# UNITED STATES PATENT AND TRADEMARK OFFICE

APPLICATION NO.	FILING DATE	FIRST NAMED INVENTOR	ATTORNEY DOCKET NO.	CONFIRMATION NO.
10/756,939	01/14/2004	Jin-Ho Park	21C-0108	3289
23413 7590 07/24/2007 CANTOR COLBURN, LLP 55 GRIFFIN ROAD SOUTH BLOOMFIELD, CT 06002			EXAMINER BODDIE, WILLIAM	
			ART UNIT 2629	PAPER NUMBER
			MAIL DATE 07/24/2007	DELIVERY MODE PAPER

<b>Office Action Summary</b>	<b>Application No.</b> 10/756,939	<b>Applicant(s)</b> PARK, JIN-HO	
	<b>Examiner</b> William L. Boddie	<b>Art Unit</b> 2629

### **DETAILED ACTION**

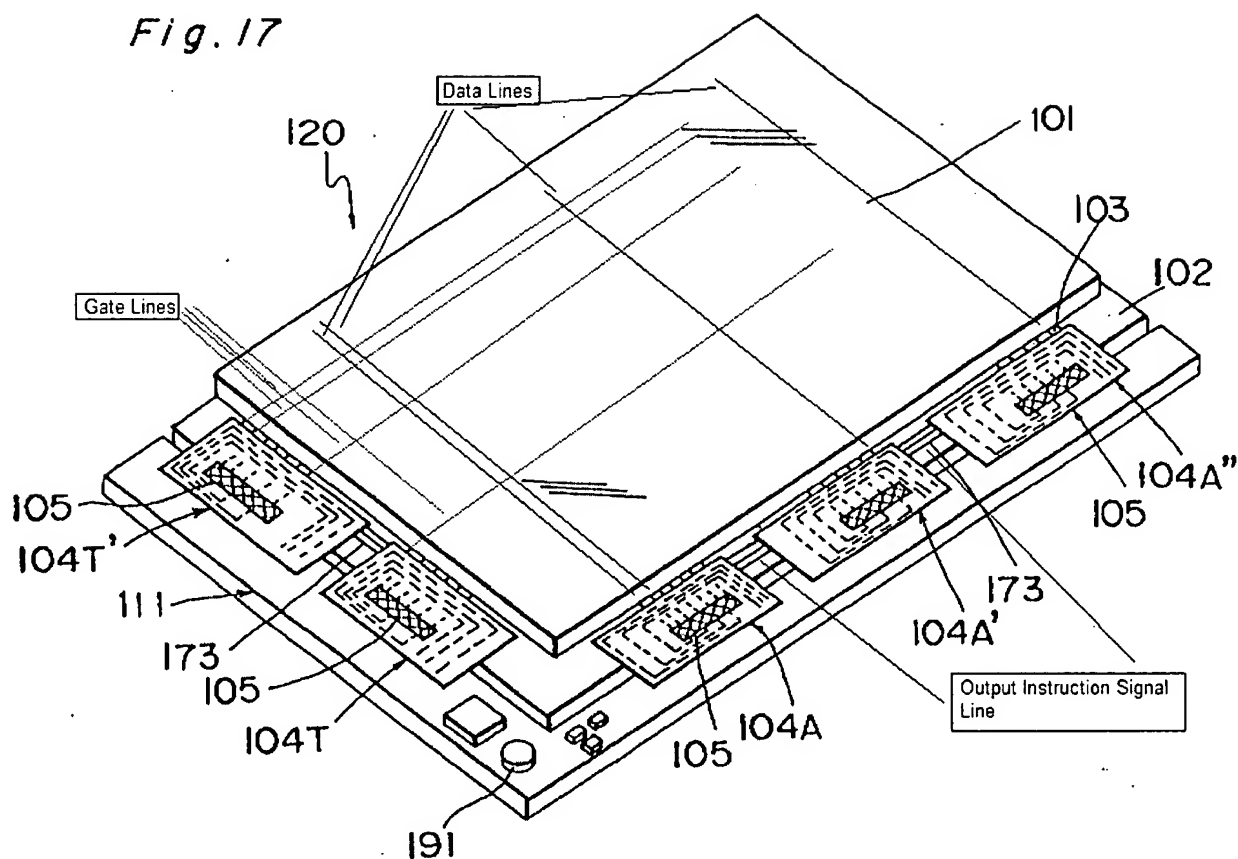
3. Applicant's arguments with respect to claims 1-11 have been considered but are moot in view of the new ground(s) of rejection.
4. In an effort to increase the understanding of the mapping of the claimed limitations to Kawaguchi and further prosecution figure 17 of Kawaguchi has been annotated and included below.

It is the Examiner's hope that this annotated drawing will clearly demonstrate how the currently claimed limitations are anticipated and/or obviated by Kawaguchi.

The Examiner must respectfully disagree. Hopefully this point is clear to the Applicants upon review of the above-annotated figure. It seems quite evident to the Examiner that Kawaguchi discloses an output instruction signal line that is parallel to the gate lines of the display panel.

wherein the gate line and the output instruction signal line are disposed substantially parallel to each other (gate lines are seen as the parallel lines that are output from 104T and 104T' into the panel, while the output instruction signal lines are seen as the 173 wiring that connects 104A – 104A''; should be clear from fig. 17 that these two sets of lines are parallel to one another) on the same substrate (col. 23, lines 54-56).

wherein the gate line and the output instruction signal line are disposed substantially parallel to each other (gate lines are seen as the parallel lines that are output from 104T and 104T' into the panel, while the output instruction signal lines are seen as the 173 wiring that connects 104A – 104A''; should be clear from fig. 17 that these two sets of lines are parallel to one another) on the same substrate (col. 23, lines 54-56).

wherein the gate line and the output instruction line are disposed substantially parallel to each other (gate lines are seen as the parallel lines that are output from 104T and 104T' into the panel, while the output instruction signal lines are seen as the 173 wiring that connects 104A – 104A''; should be clear from fig. 17 that these two sets of lines are parallel to one another) on the same substrate (col. 23, lines 54-56).
